Application No: 19/00213/DISC

Proposal: Discharge of conditions 6 (new link road), 8 (surface water drainage), 9 (floor levels), 10 (play areas), 11 (arboricultural survey), 12 (ecology), 13 (secured by design), 14 (contamination), 18 (mitigation for badgers) and 35 (cycle lanes) of 15/01326/OUT

Location: OS Parcels 6741 And 5426 West Of Cricket Field Nor Wykham Lane Bodicote

Transport Development Control

See extract from Plan 2 below:

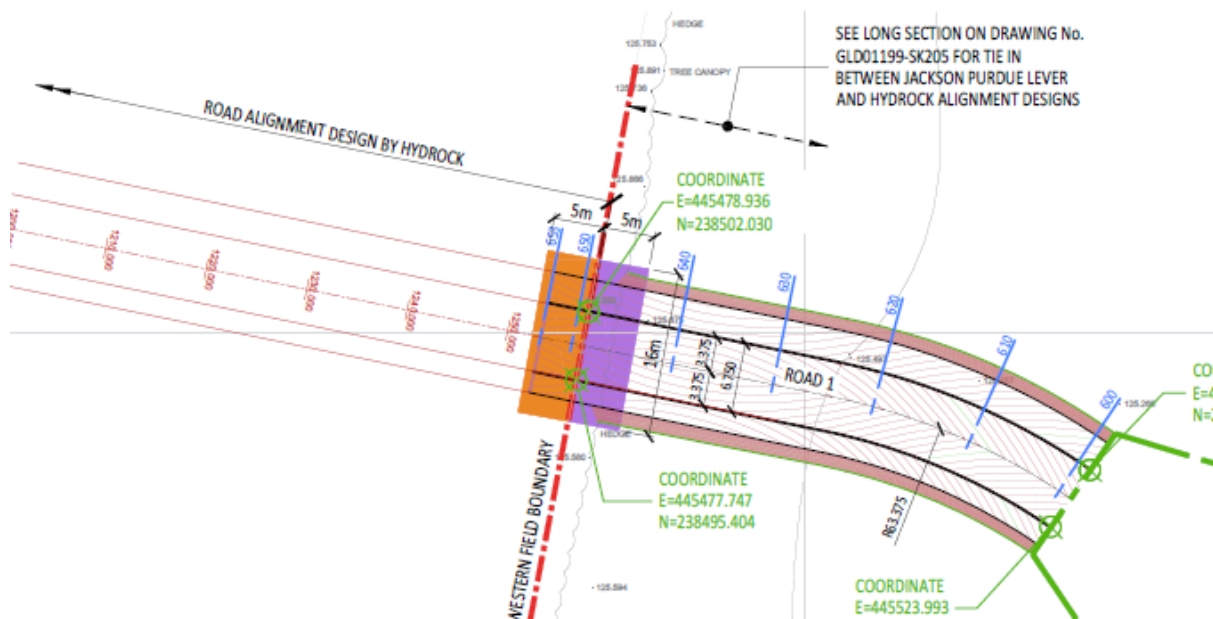
I am concerned about the join between the spine road in this site, and the spine road through the adjacent site. The UU set coordinate points for the intersection of the road and the western site boundary, and prescribed the road layout and levels in the immediate vicinity of the site – 50m either side of the boundary. Looking at the Adoptable Highway Layout, I cannot determine whether the coordinate points are correct, since they are not marked. However, the alignment looks notably different from the Plan 2 in the UU, with regard to the angle at which the road intersects the boundary, and the alignment in the 50m stretch to the east of it. This must be corrected, in order to ensure that the road joins up with the road in the adjacent site, with a suitable alignment.

Further, the road is not coloured to the boundary. Construction and adoptable areas must be shown right to the boundary, to meet the requirements of the UU.

Also the corridor is not as wide as shown on the Plan 2, which shows a service margin or verge at the back of the footway. This must be corrected.

At the eastern end of the spine road, coordinate points should also be marked, to demonstrate that it meets the requirements of the UU, although in any event, there will need to be tie in with the S278 works to realign White Post Road, which are the responsibility of the developer.
